**RE: DEVELOPMENT APPLICATION 2019/0080
34 BEATTY STREET, BALGOWLAH HEIGHTS**

This submission is written on behalf of Christopher Rushton at 36 Beatty Street, Balgowlah Heights (the **neighbouring owner**) and is in respect of the above Development Application (**DA**) proposing substantial alterations and additions to the existing dwelling house and its surrounds at 34 Beatty Street, Balgowlah Heights (the **site**).

Figure 1 – Axonometric diagram of the proposed built form and its walled effect to the useable backyard of 36 Beatty Street (source CHROFI DA-901 A)

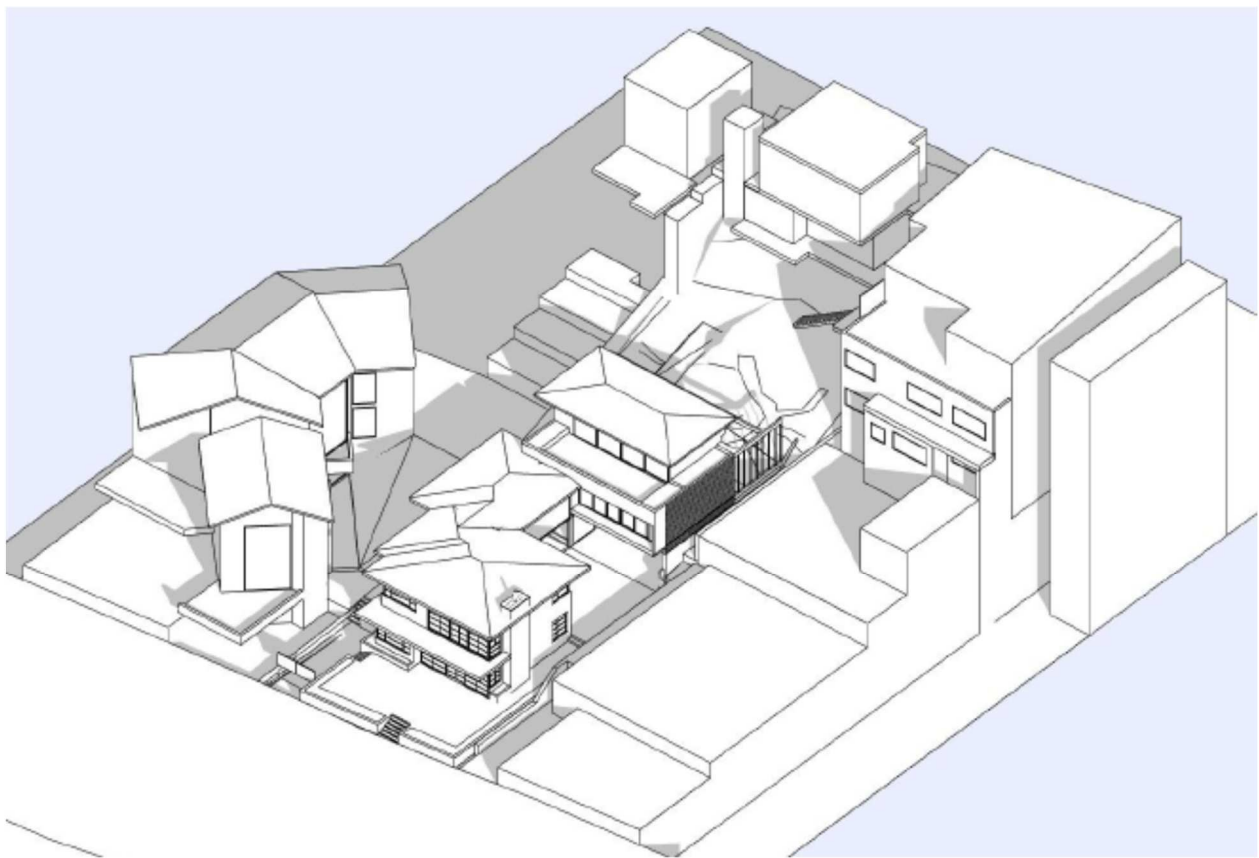
- the curtilage to the neighbouring properties relative to apparent built form is significantly reduced. This results in a 'continual' wall of built form presented to the shared boundary between the site and 36 Beatty Street. This walled affect is demonstrated at **Figure 1**. The limited separation accentuates the environmental impacts;

In addition to the above and generally, the overall built form should be stepped further away from the neighbouring owner, comply with the height standard, wall height and setback guidelines. Additionally alternative materials and finishes should be considered to alleviate the stark white built form outlook which would result if approved as currently proposed.
